## ADDENDUM 1 – JOB 47

TO: All prospective bidders on project TAU-8-984(154)157, Job No. 47 scheduled for the November 17, 2017 bid opening.

Addendum 1 is to address: Revising special provisions. Adding landscape boulders to protect path wall. Updating bridge quantities, details, notes.

REVISION 11/06/17	STATE	PROJECT NUMBER	SECTION NO.	SHEET NO.
	ND	TAU-8-984(154)157	170	1

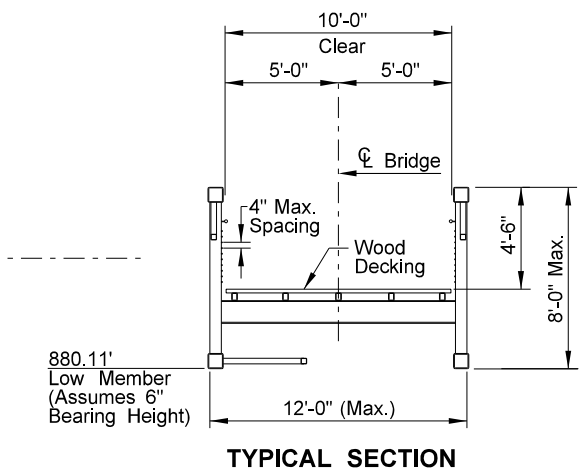
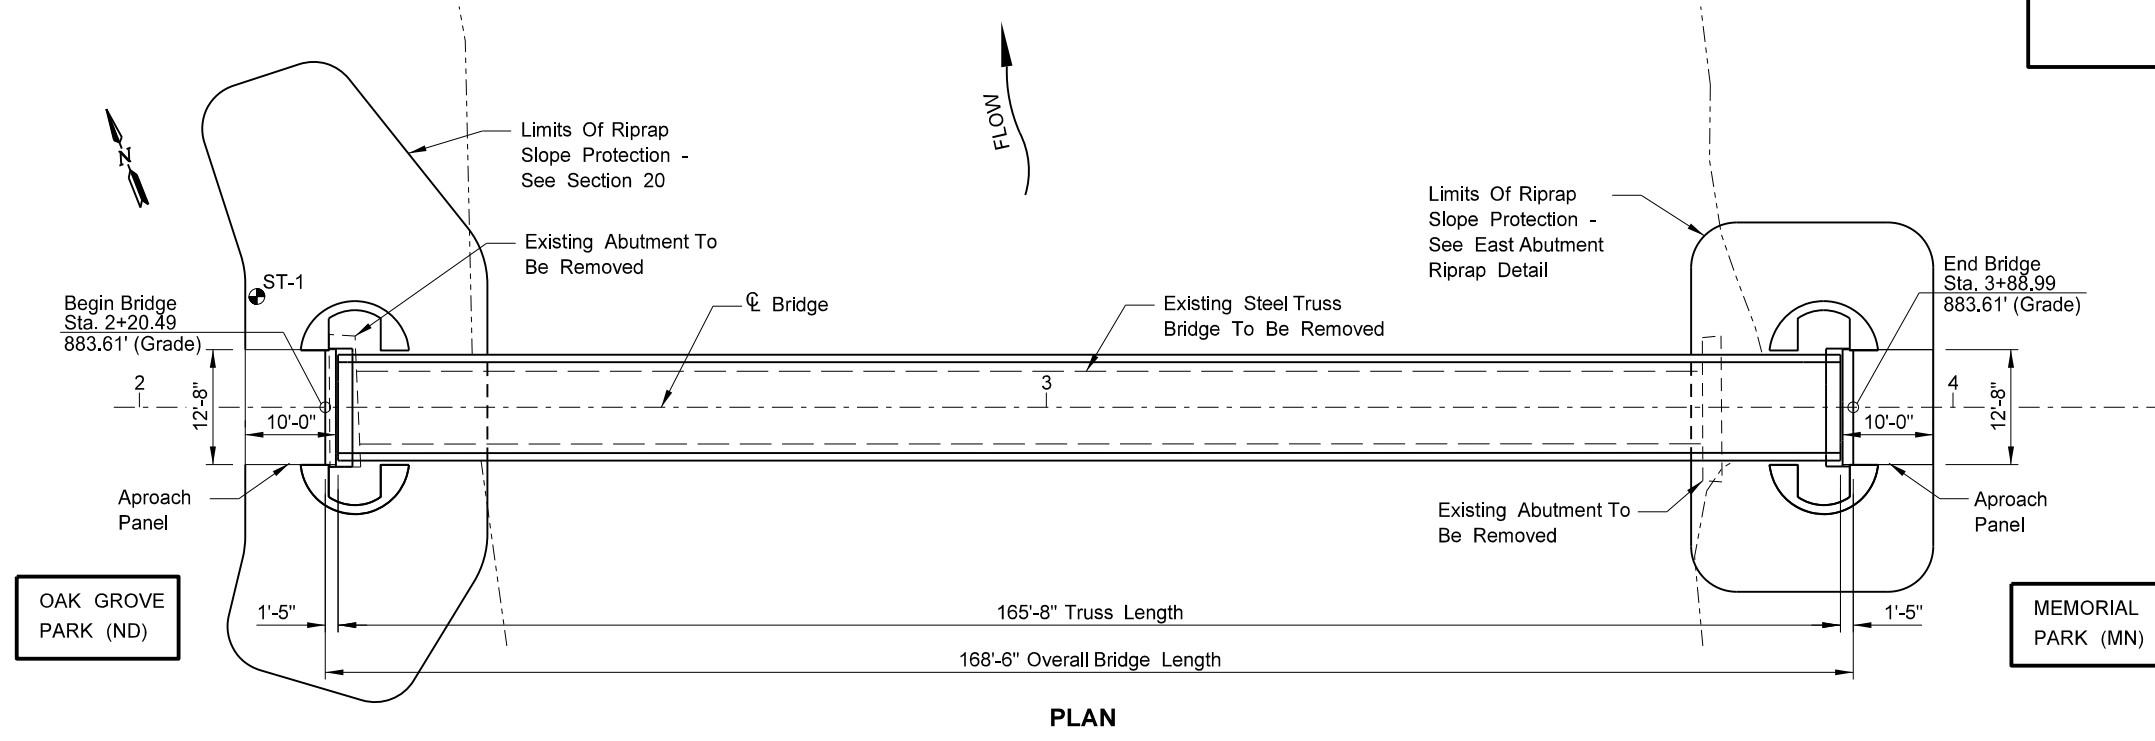
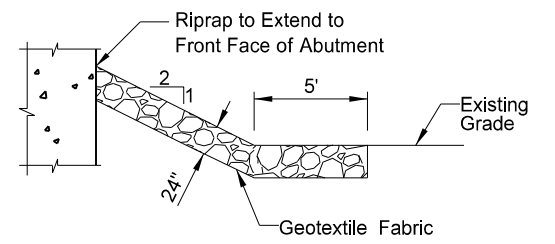
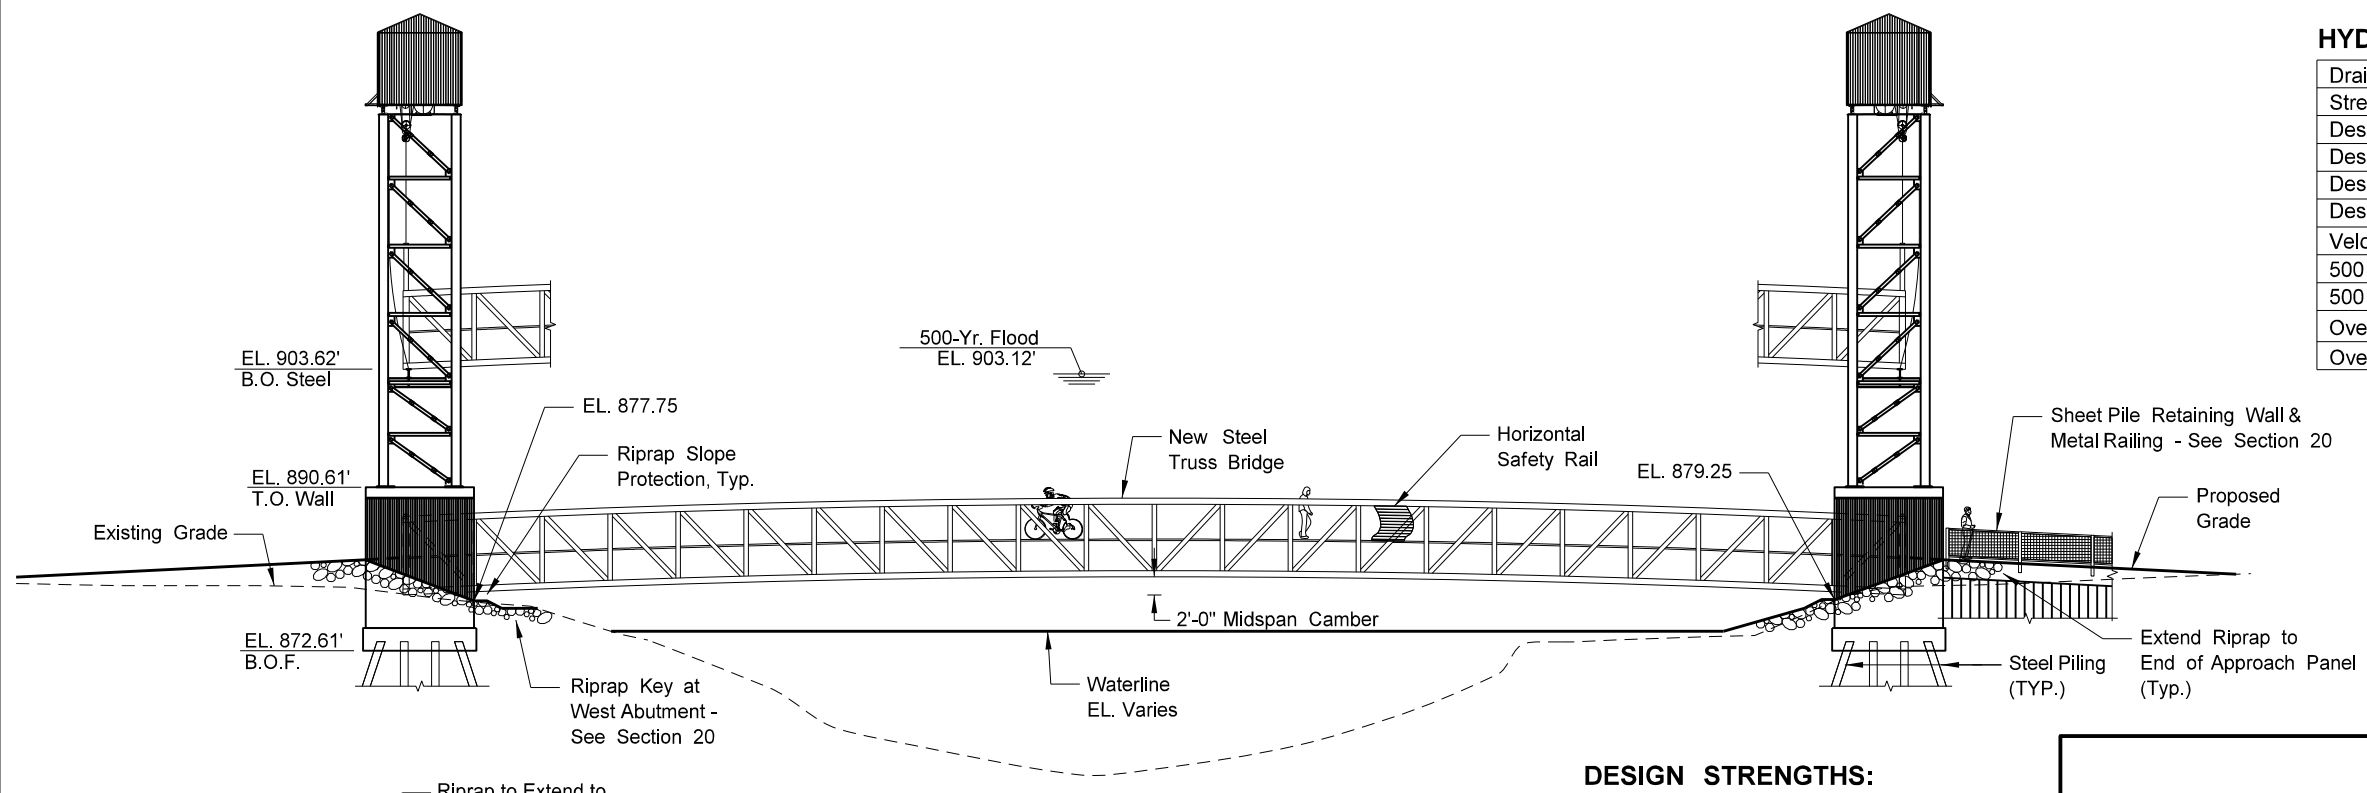
Miscellaneous text revisions and elevations added.

REVISION	11/06/17	STATE	PROJECT NUMBER	SECTION NO.	SHEET NO.
		ND	TAU-8-984(154)157	170	5

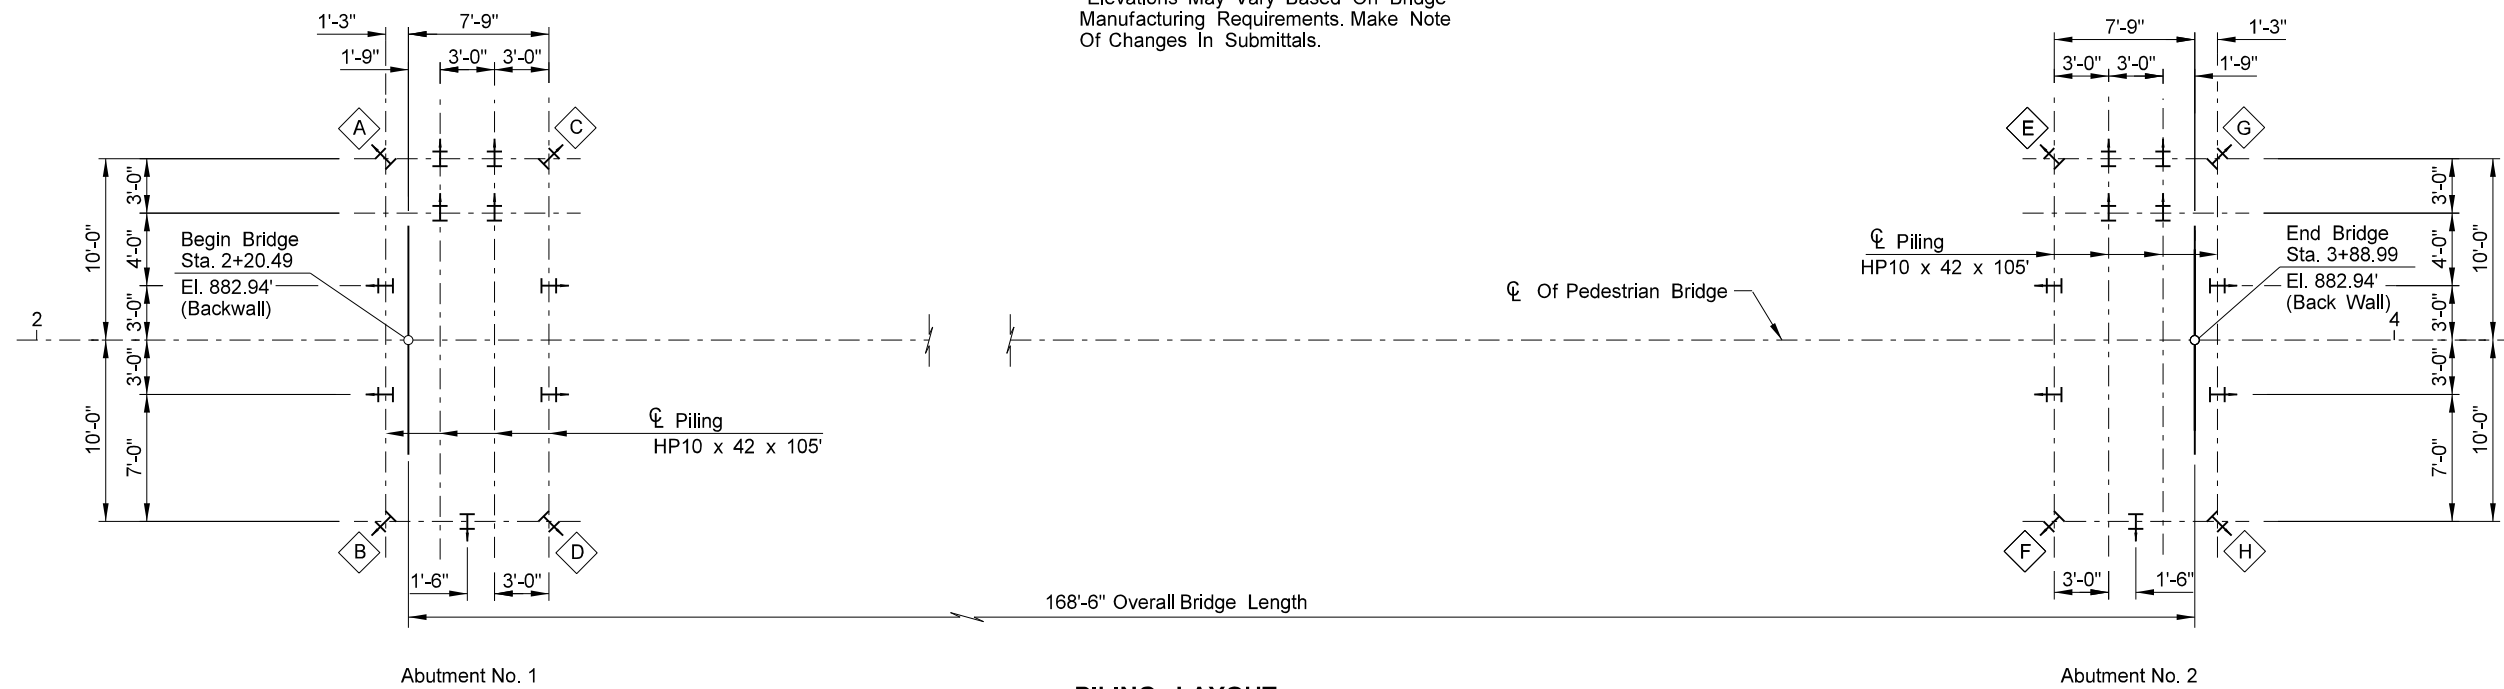
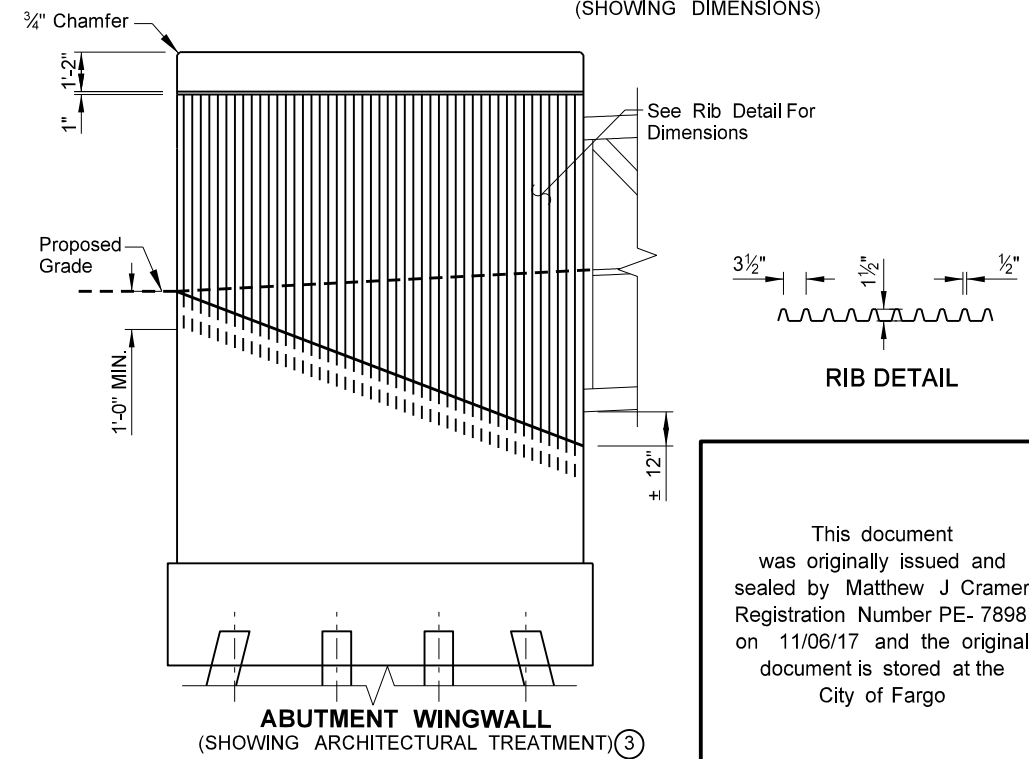
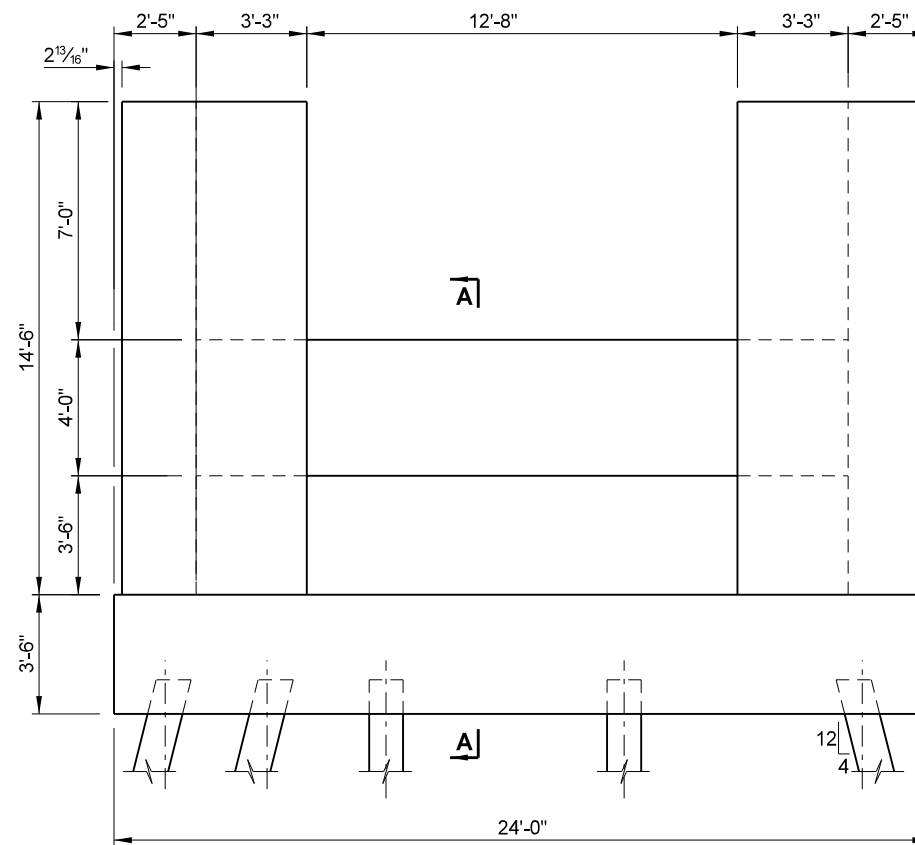
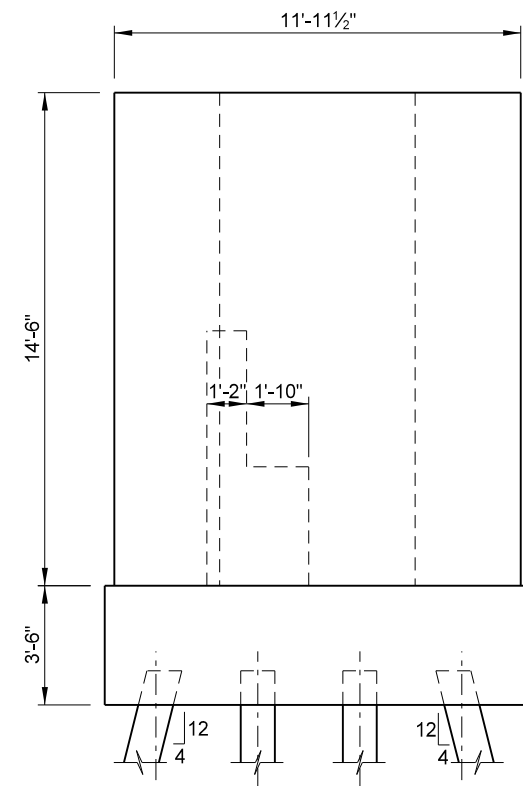
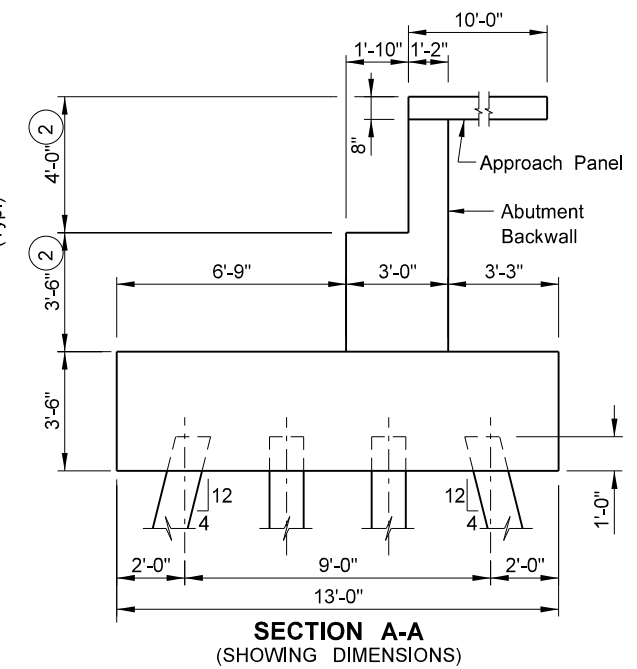
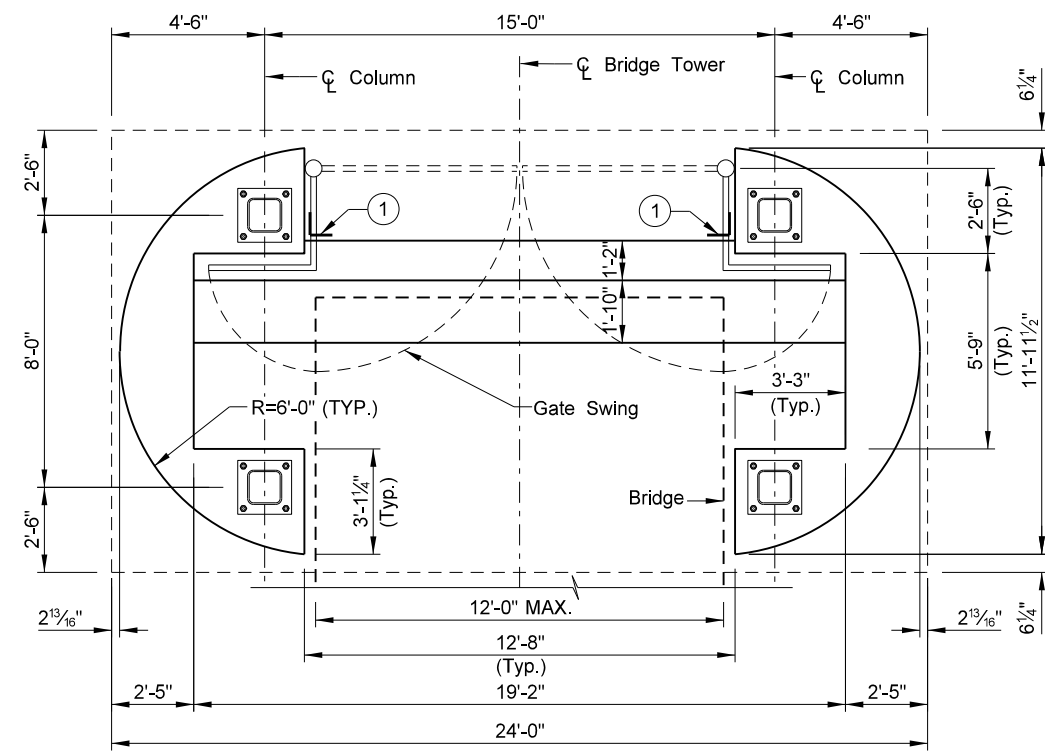
One pile added each abutment, removed bid item 930 9930 Anti-Graffiti Coating, revised quantities for 612 0116 Reinforcing Steel-Grade 60-Epoxy Coated and 622 0020 Steel Piling HP 10x42.
